ADVANCED NUHOMS® SAR REVISED PAGES (REVISION 4)

ANUH-01.0150
Revision 4

**SAFETY ANALYSIS REPORT
FOR THE
STANDARDIZED ADVANCED NUHOMS®
HORIZONTAL MODULAR STORAGE SYSTEM
FOR IRRADIATED NUCLEAR FUEL**

Revision 4
July 2001

Figure 12.4-1
Minimum Spacer Disc Ligament Widths

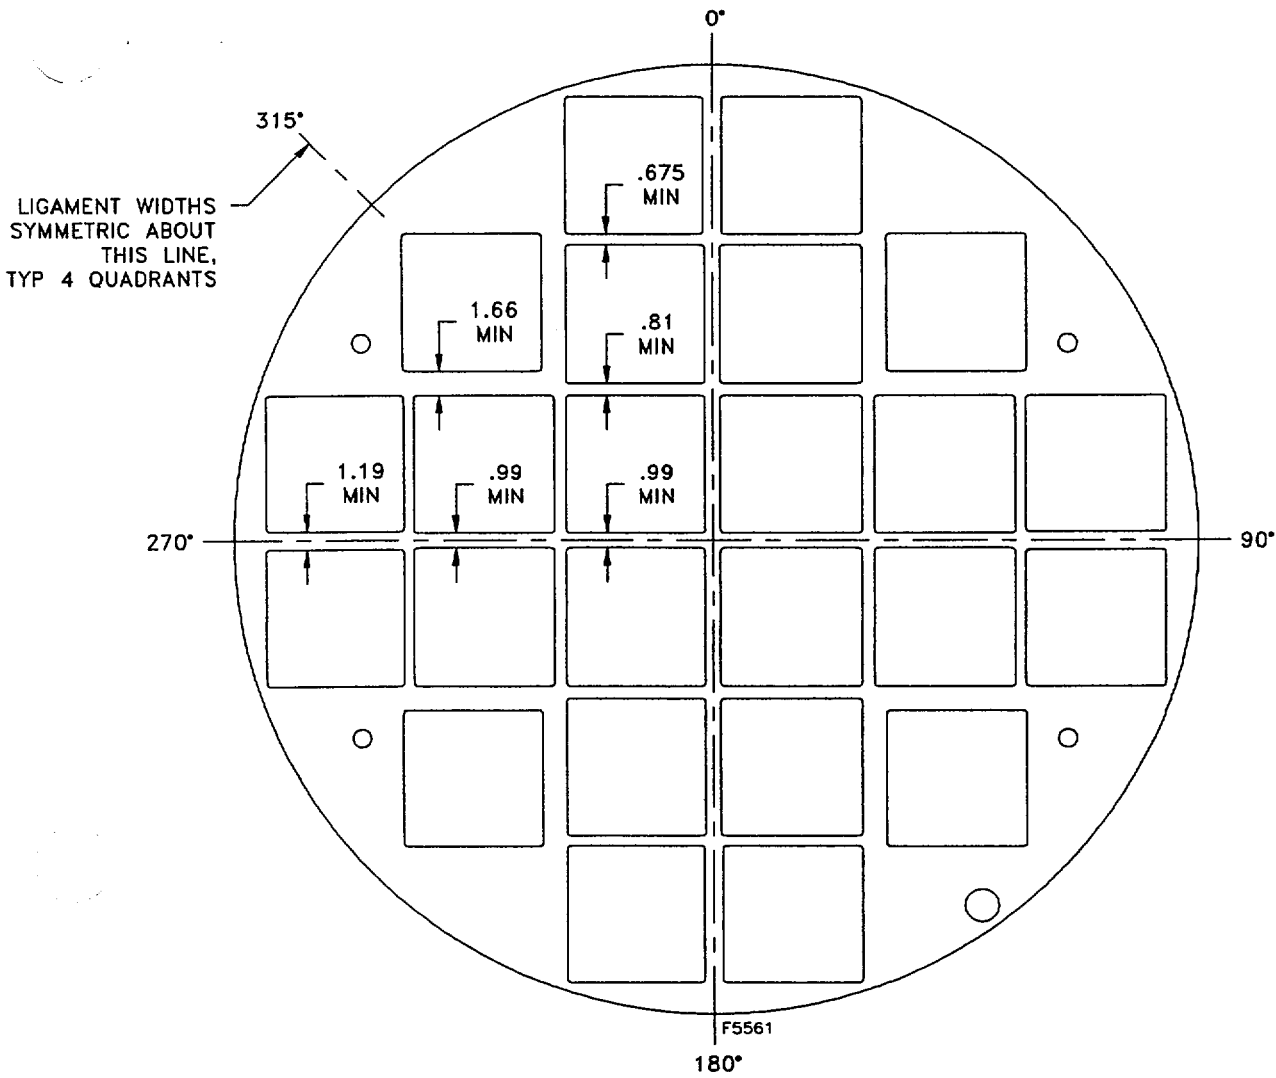
The canister flux trap configuration is defined by the spacer disc ligament width dimensions. Figure 12.4-1 shows the location and dimensions of the ligaments (the dimensions shown in the one quadrant are applicable to all four quadrants).
